## HISTORIC AND DESIGN REVIEW COMMISSION

March 01, 2017

**HDRC CASE NO:** 2017-067  
**ADDRESS:** 327 RIVERSIDE DR  
331 RIVERSIDE DR  
**LEGAL DESCRIPTION:** NCB 7456 LOT 1 (1.564 AC), A3 (2.368 AC), A4 (4.116 AC), A7(.678 AC), & A8 (1.583 AC)  
**ZONING:** I-1 RIO-5  
**CITY COUNCIL DIST.:** 3  
**APPLICANT:** Mike Frere/84 Lumber  
**OWNER:** Stampede Industries, LLC  
**TYPE OF WORK:** Construction of two storage structure, site work  
**REQUEST:**

The applicant is requesting conceptual approval to perform site work and construct two rear storage structures at 327 and 331 Riverside Drive.

LANDSCAPE PLAN  
84 LUMBER  
331 RIVERSIDE DRIVE  
SAN ANTONIO, TEXAS 78210

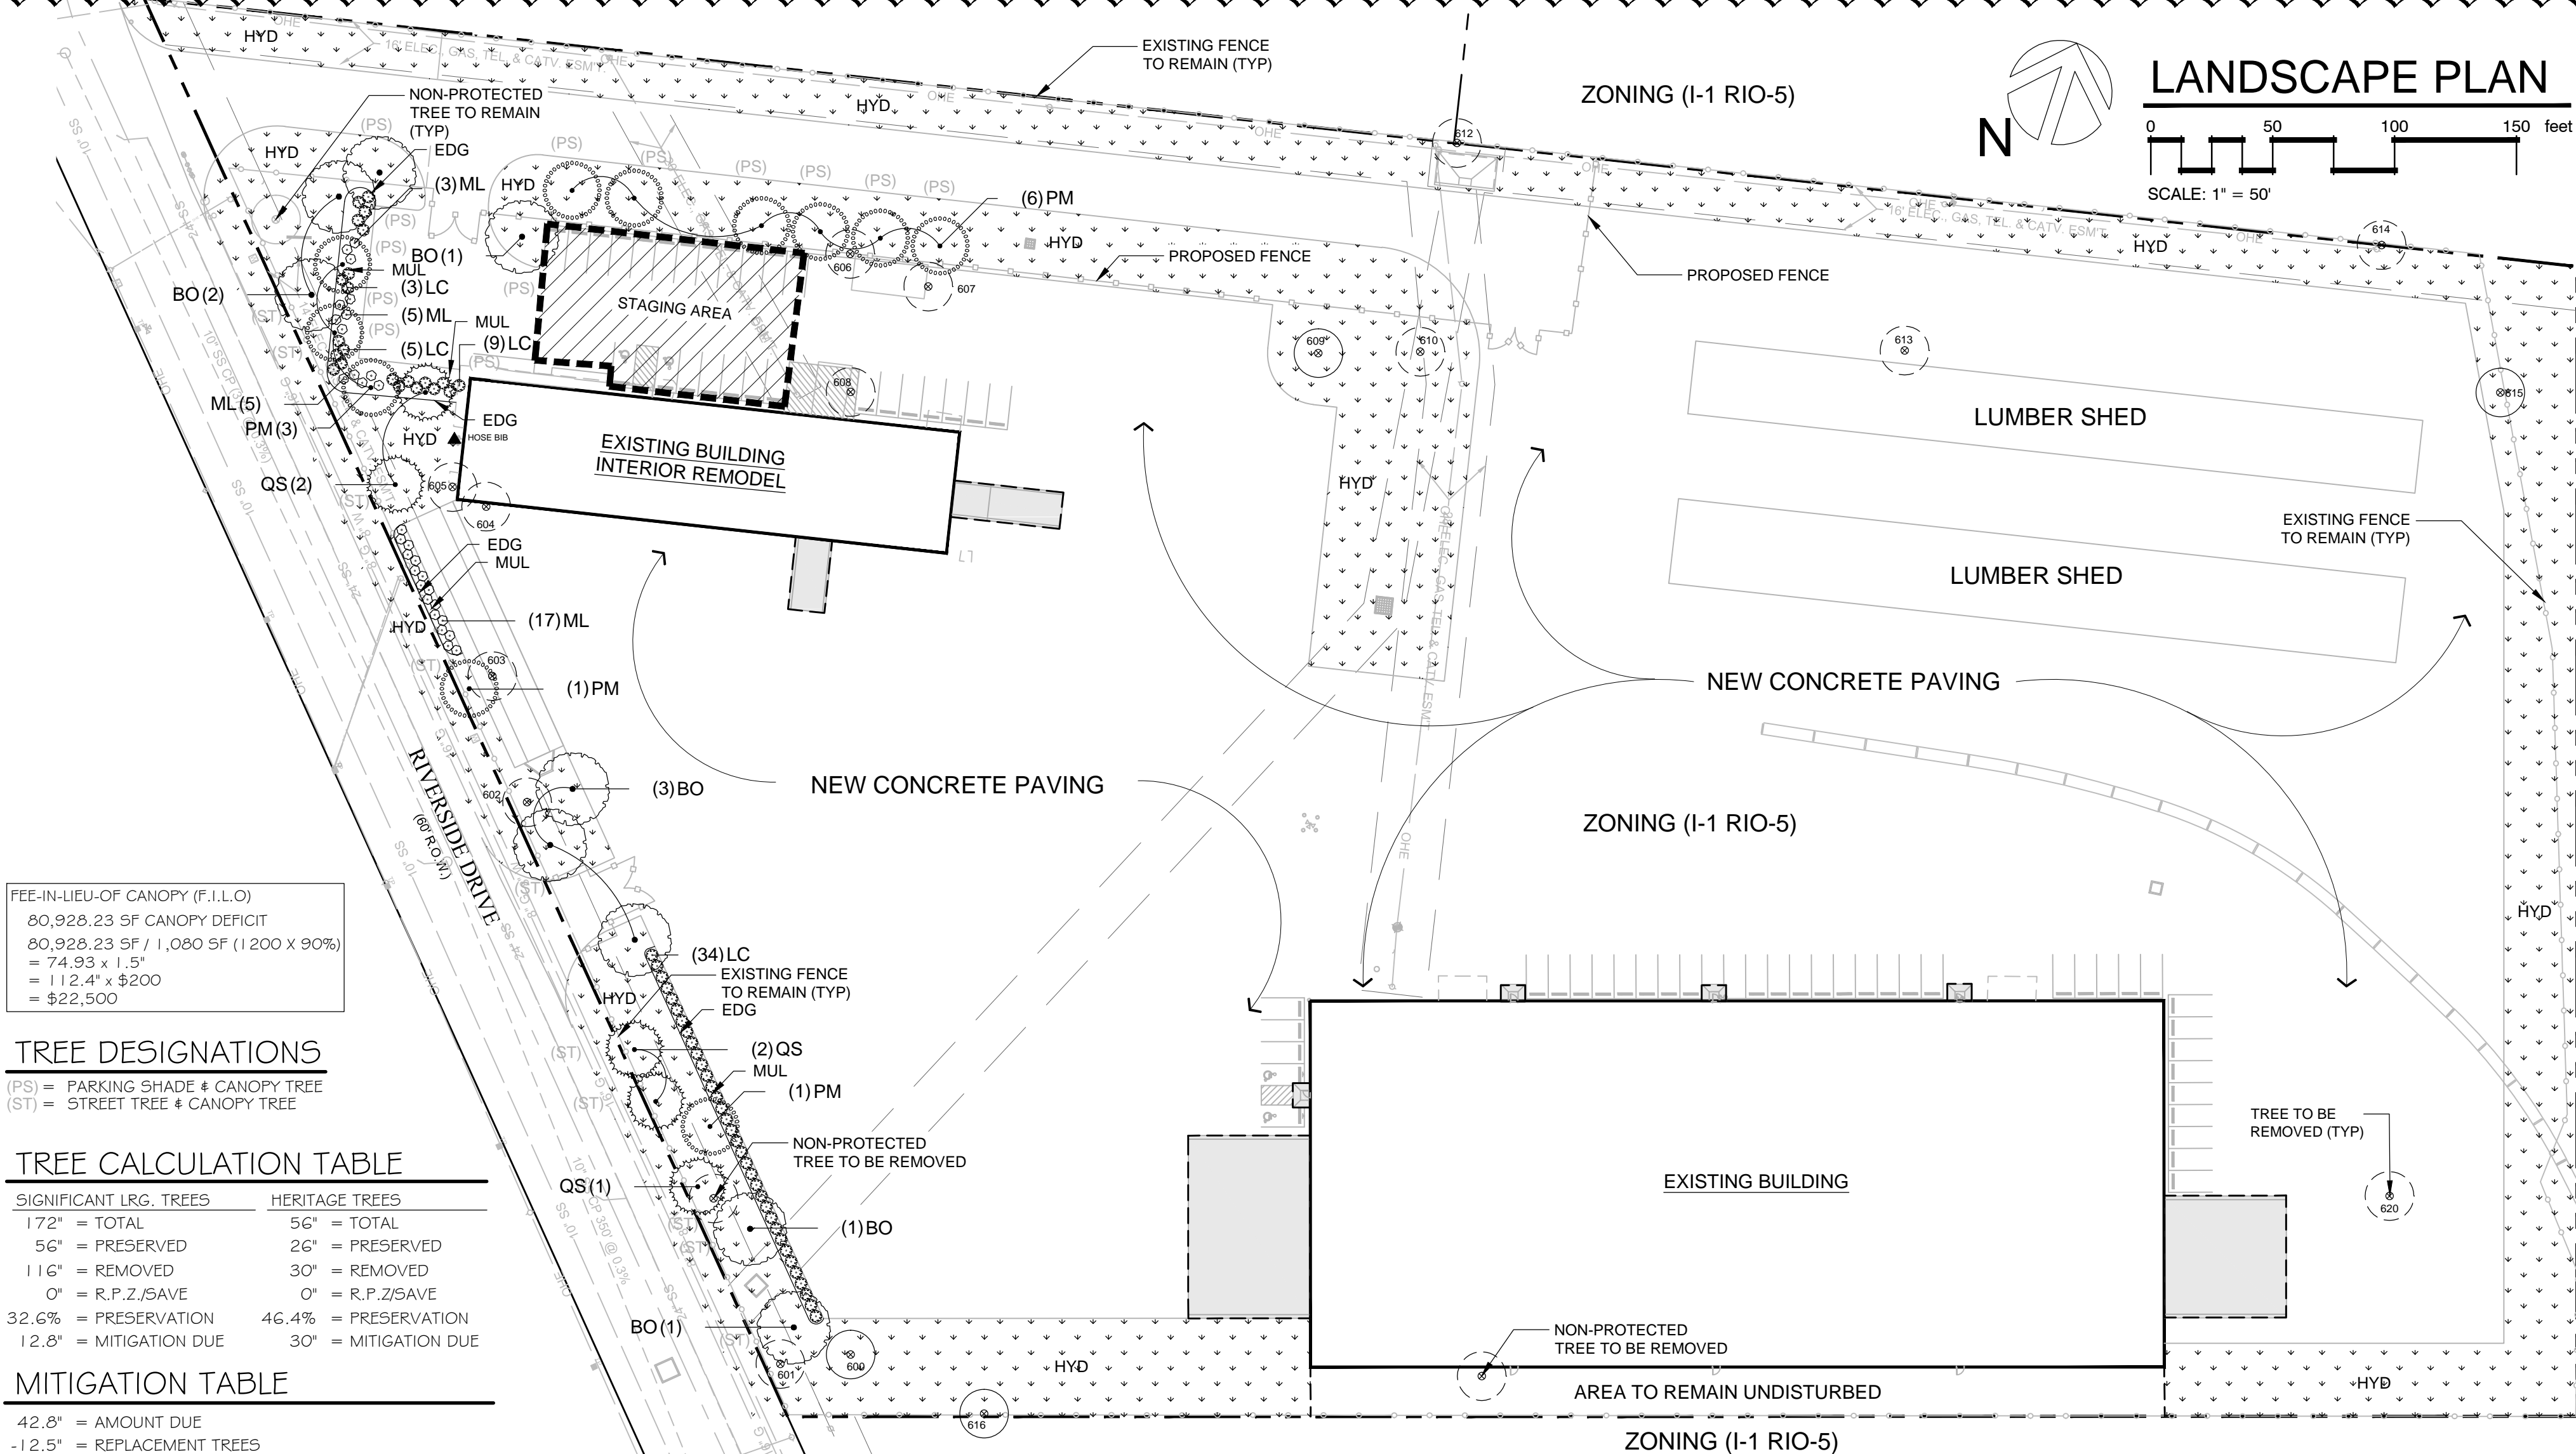
- e. LANDSCAPE DESIGN – The applicant has provided a site plan noting the location of proposed modifications. Regarding landscaping, the applicant has not provided specific information regarding landscaping materials. As noted in finding b, all surface parking locations must be buffered by landscaping elements. The applicant is to provide a plan for buffering each parking location from view at the public right of way.

8,100 S.F. HALF SHED  
FOUND/FLOOR/ELEVATION PLAN  
331 RIVERSIDE DRIVE

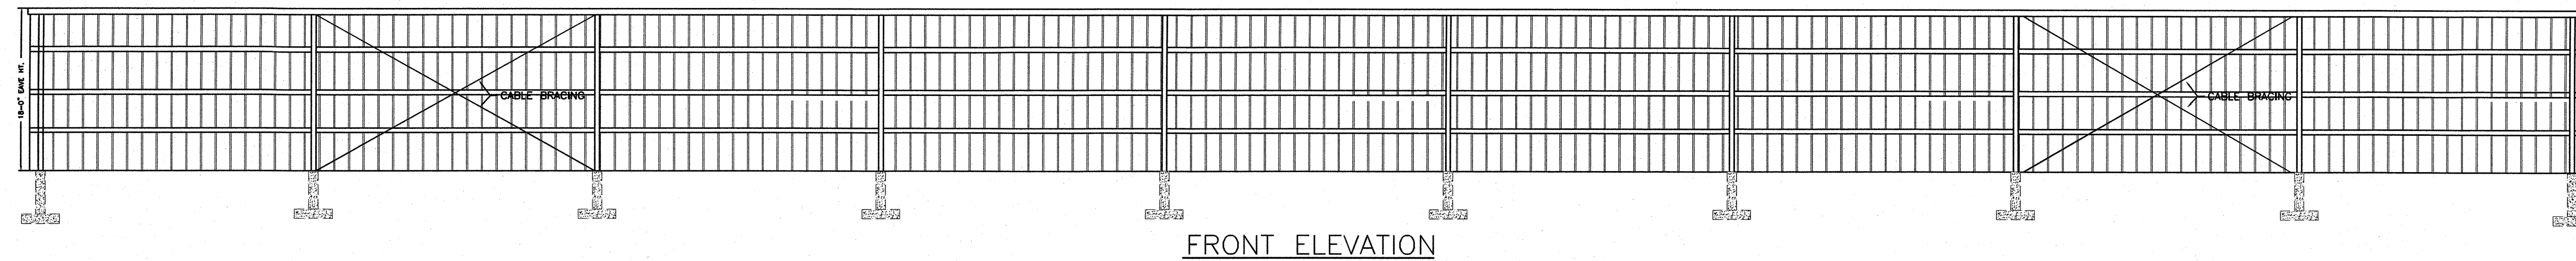
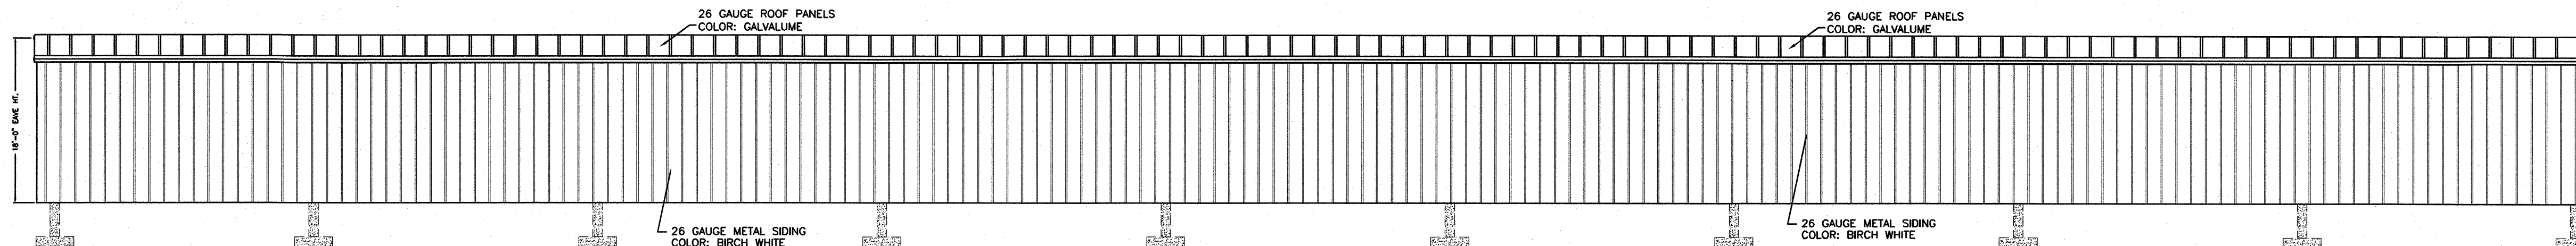
- f. NEW CONSTRUCTION – The applicant has proposed to construct two separate storage structures that are to be enclosed on one elevation. Both structures will feature an overall length of 270 feet. The northern structure will feature a width of 30 feet and the southern structure will feature a width of 40 feet. Staff finds the construction of a storage facility that is enclosed on only three sides appropriate given that both open sides are facing existing industrial properties and are not open to the public right of way.
